## CERTIFICATE OF APPROPRIATENESS

**Property:** 1106 Columbia St, Tracts 14 and 15A, Block 196, Houston Heights Subdivision. The property includes a historic 1,000 square foot, one-story wood frame single-family residence and a detached garage situated on a 7,260 square foot (55' x 132') interior lot.

**Proposal:** Alteration – Addition *Revision*

The applicant proposes the following revisions to a COA approved by the HAHC on 7/28/2016 for a two-story addition to the rear of the existing residence:

**NORTH SIDE ELEVATION**

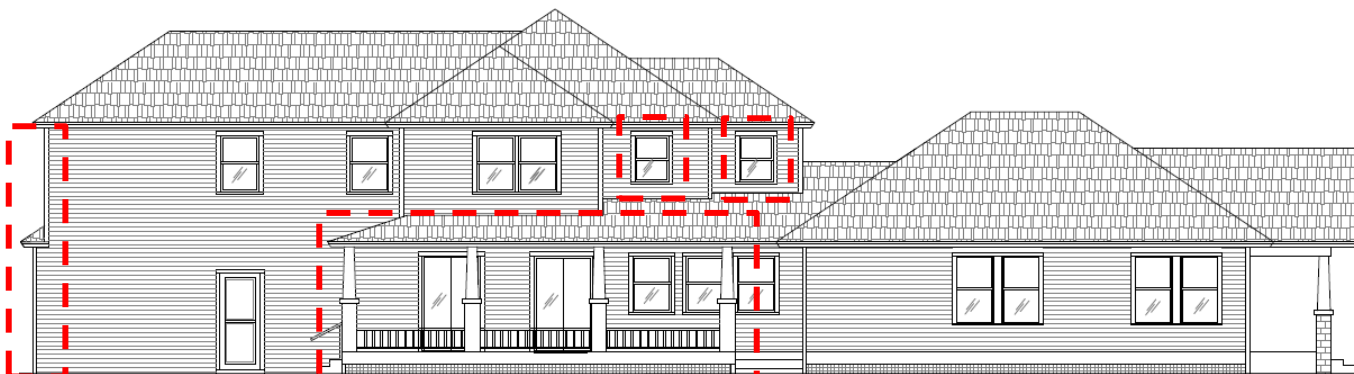
- Increase the depth of the addition from 62' to 64'. The first level of the addition will be 1' deeper than the second level.
- Increase the width of the porch on the north elevation of the addition from 20' to 38'.
- Reduce the size of two windows on the north elevation of the second level of the addition. For further detail, see North Side Elevation on p. 6 and Window Detail – North Elevation Second Level on p. 12.
- Alter the fenestration pattern on the second level of the south elevation of the addition. The specifications of the windows remain the same. For further detail, see South Side Elevation on p. 7 and Window Detail – South Elevation Second Level on p. 12.

Proposed: The side porch will measure approximately 38' wide by 15' deep. Two windows on the second level of the addition will be reduced from 3'-0" x 5'-0" and 3'-2" x 4'-8" to 3'-0" x 4'-0".

**SOUTH SIDE ELEVATION**

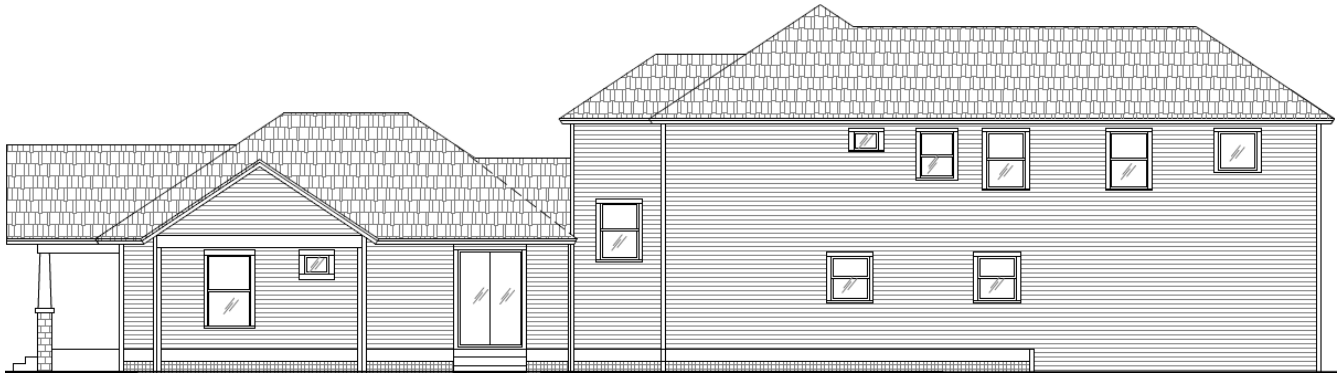
Proposed: Two 3'-2" x 4'-8" double-hung wood windows on the second level of the addition will be moved closer together to form a set.

**FIRST FLOOR PLAN**

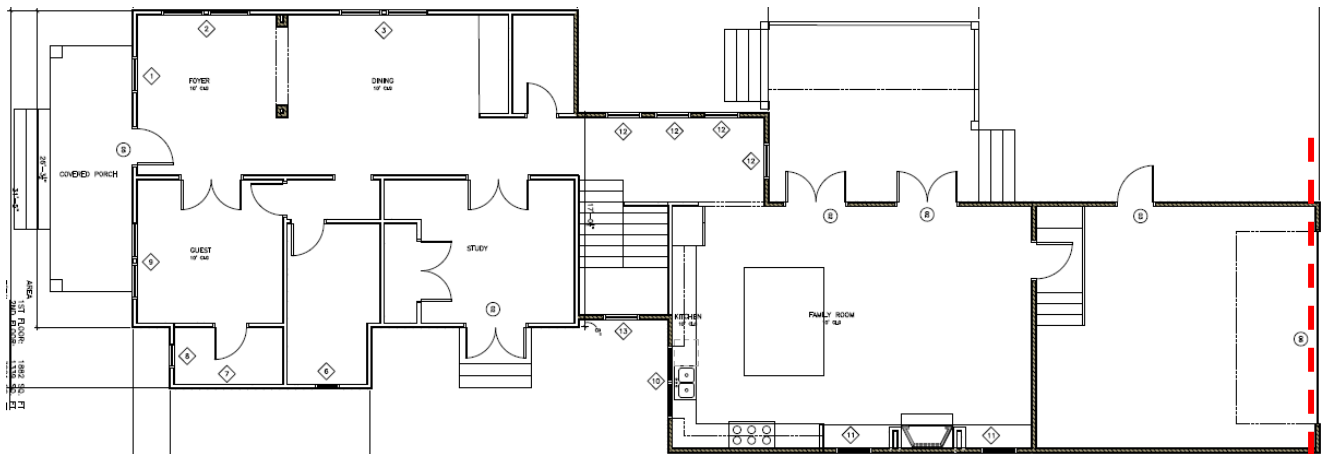
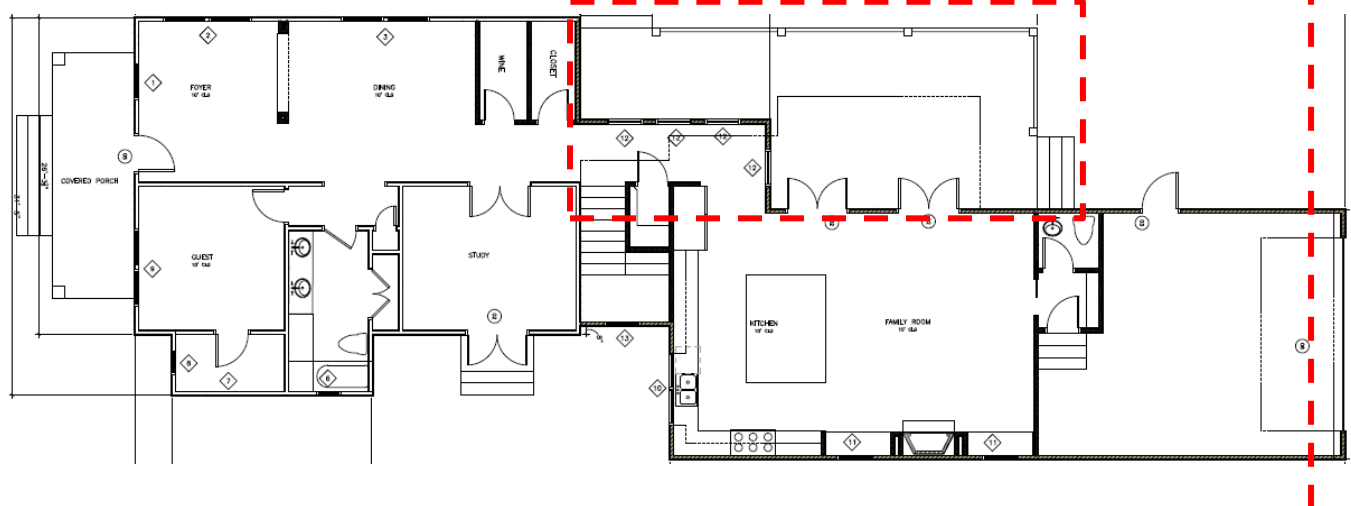
Proposed: The overall depth of the addition will increase from 62' to 64'.

Proposed: The addition will be setback 11' from the rear property line.
